**Proposed changes to Timaru Mandatory  
Broadcast Zone  
- airspace user consultation**

Figure 2 – requested airspace changes

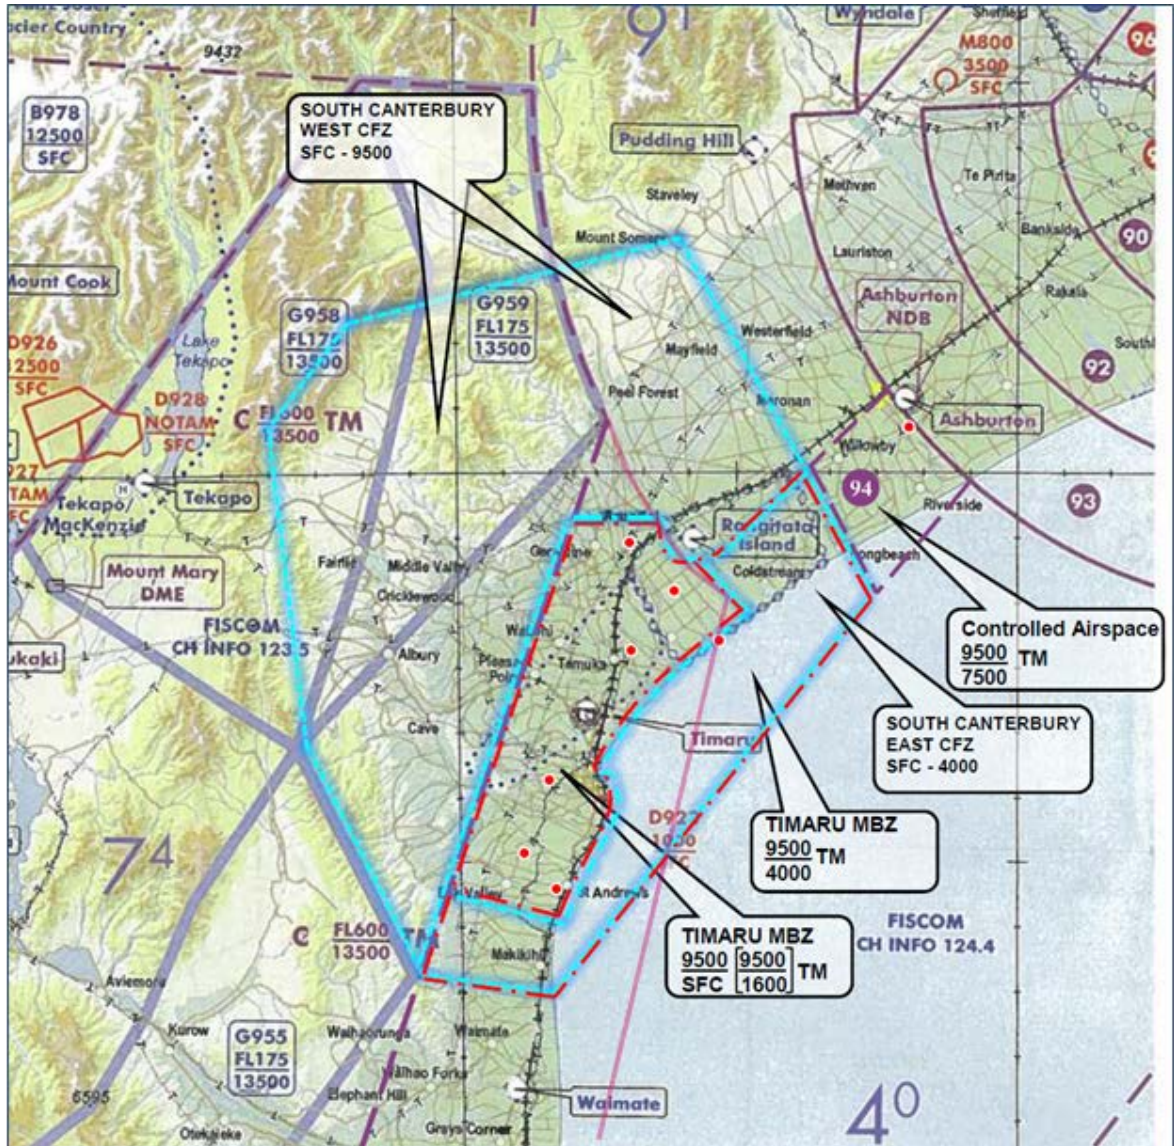
At present pilots are required to report every five minutes inside the MBZ. This is not onerous in a small MBZ of approximately 16 NM by 5 NM (80 NM<sup>2</sup>), as it equates to normal reporting intervals when operating within the vicinity of an aerodrome i.e. circuit area. If the MBZ is extended in size, it will become approximately 50 NM by 15 NM (750 NM<sup>2</sup>), with associated reporting requirements.

When designating uncontrolled airspace as transponder mandatory, the lower limit is generally at 1500 ft AGL or above for the following reasons:

- limitations in airborne collision avoidance system (ACAS) design and parameters. ICAO and European documents highlight these limitations when operating within aerodrome circuits and below 900 ft AGL. Eurocontrol's ACAS Bulletin No.6 describes the problem:  
*'The TCAS II traffic display can be misinterpreted, since it provides only partial information, it has limited accuracy, and it is based upon a moving reference. It has not been designed for the purposes of self-separation or sequencing, and using it for these purposes is inappropriate, and could also be hazardous. Although the ACAS traffic display assists to detect the presence of intruders in the close vicinity, flight crews should not be over-reliant on this display. It supports visual acquisition; it is not a replacement for the out-of-window scan.'* (Emphasis is original.)

- There is no provision in existing rules for aircraft with an inoperable transponder to obtain approval to operate within a transponder mandatory airspace to enable the aircraft to be flown to a maintenance base which may be located within the MBZ for repairs.

Any transponder mandatory airspace lower limit would be set at a minimum of 1500 ft AGL for if the MBZ is amended, which aligns the 1600 ft lower limit proposed for other reasons.
